Ltr	Date	By	REVISION DESCRIPTION
University of Toronto, Quantum Optics Group			
PC-11482-A		CASE	Design: A. Stummer
M2112LCW01		SWITCH	Date: 2017 July
PSM03A-120-R		ACDC	Edited: 2017-10-04 5:00 PM
File:Loch Box			Sheet: 1 of 3
			REV:A

**Loch Box**  
**Analog Laser PID**  
 A. Steinberg Labs

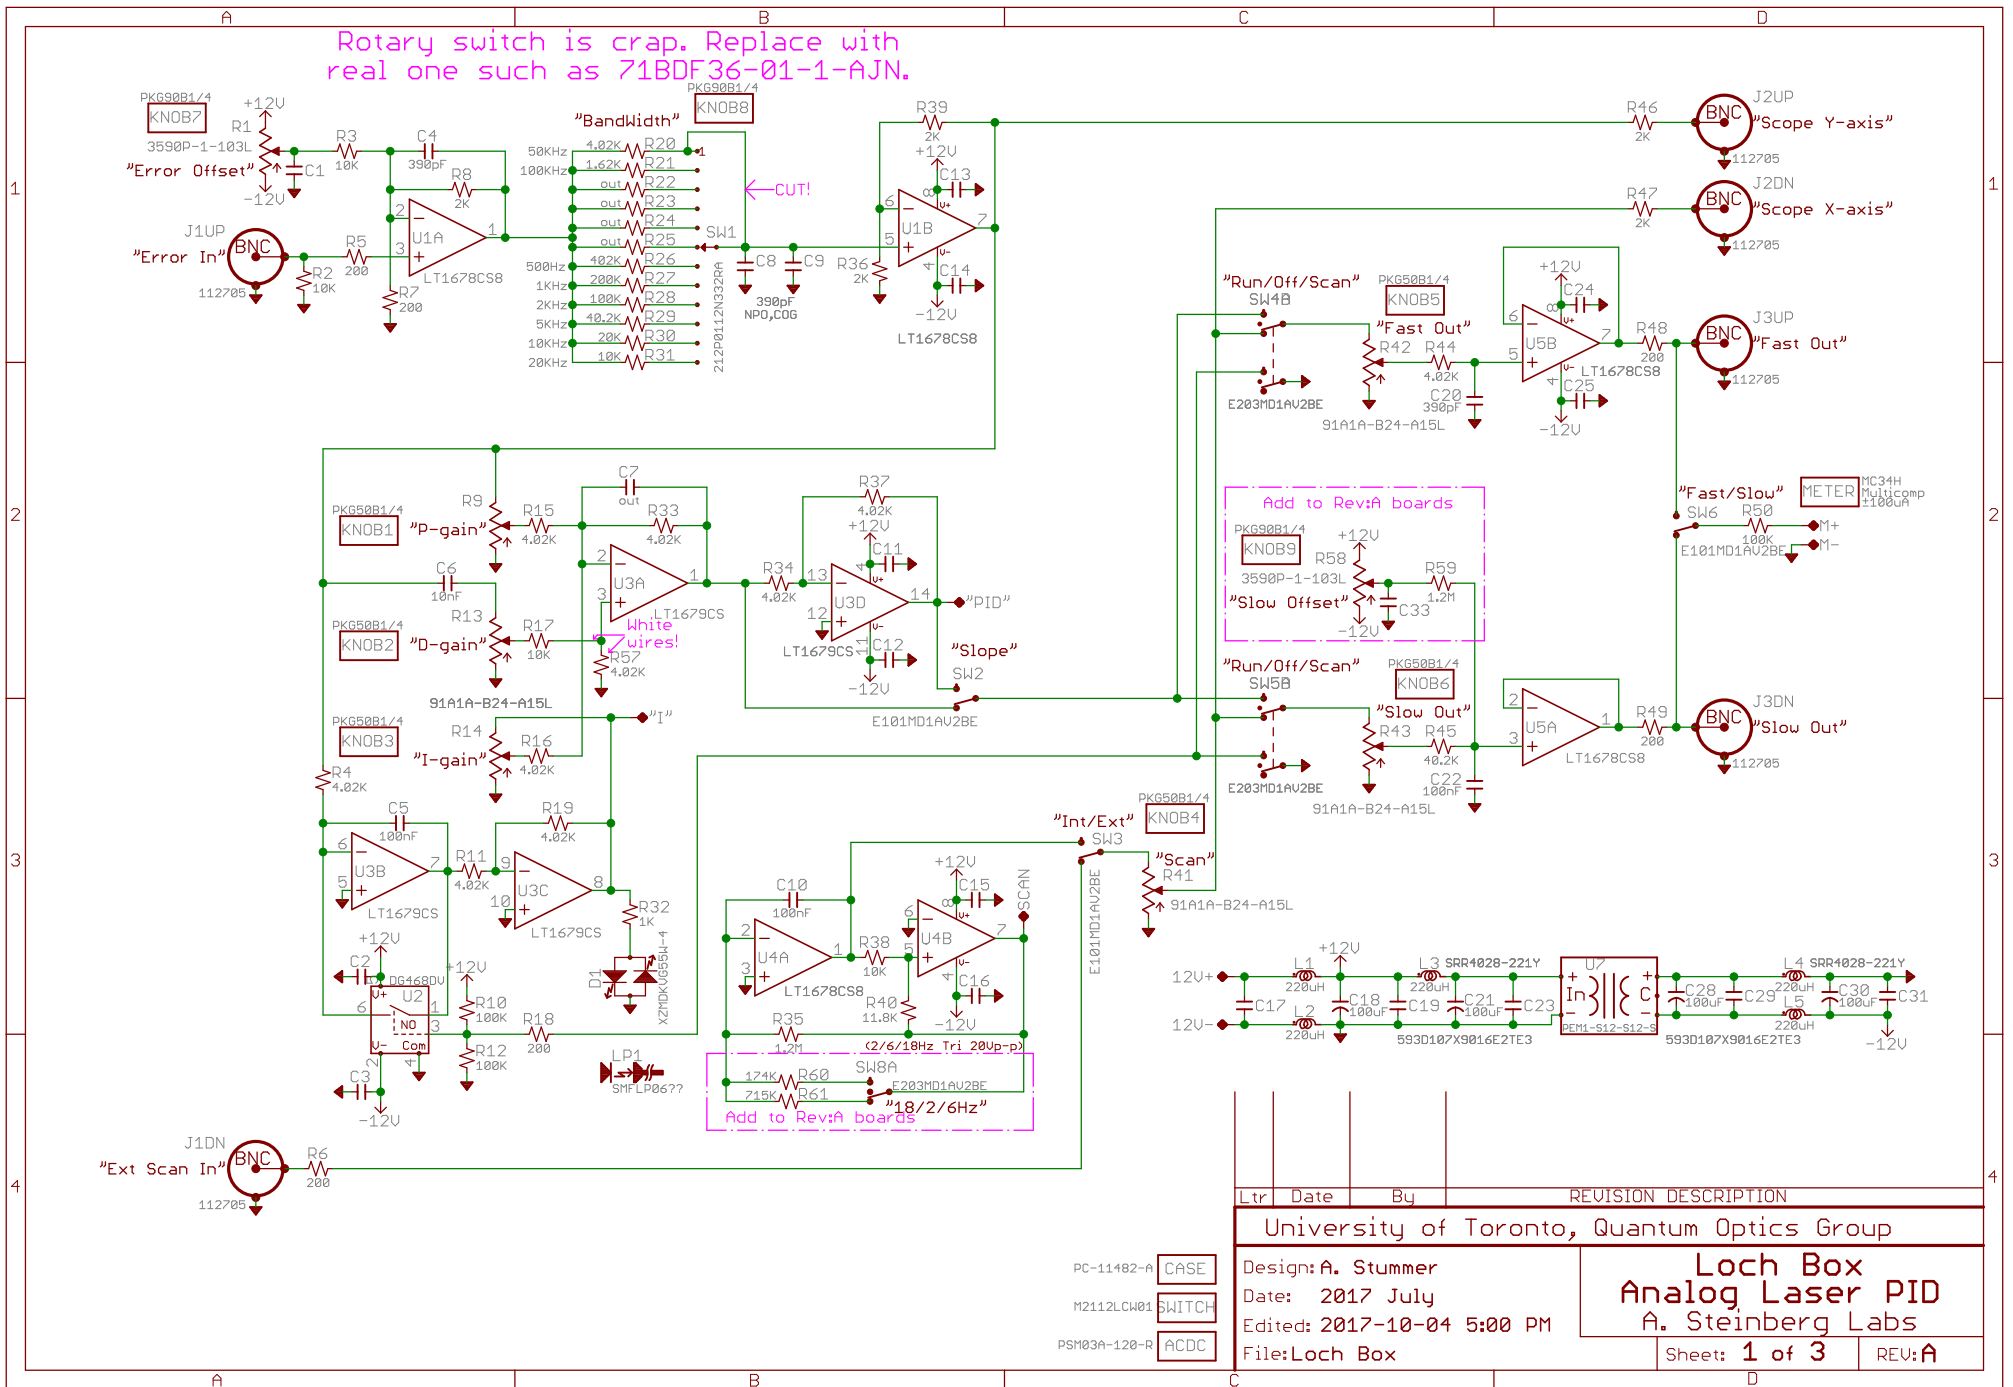
Rotary switch is crap. Replace with real one such as 71BDF36-01-1-AJN.
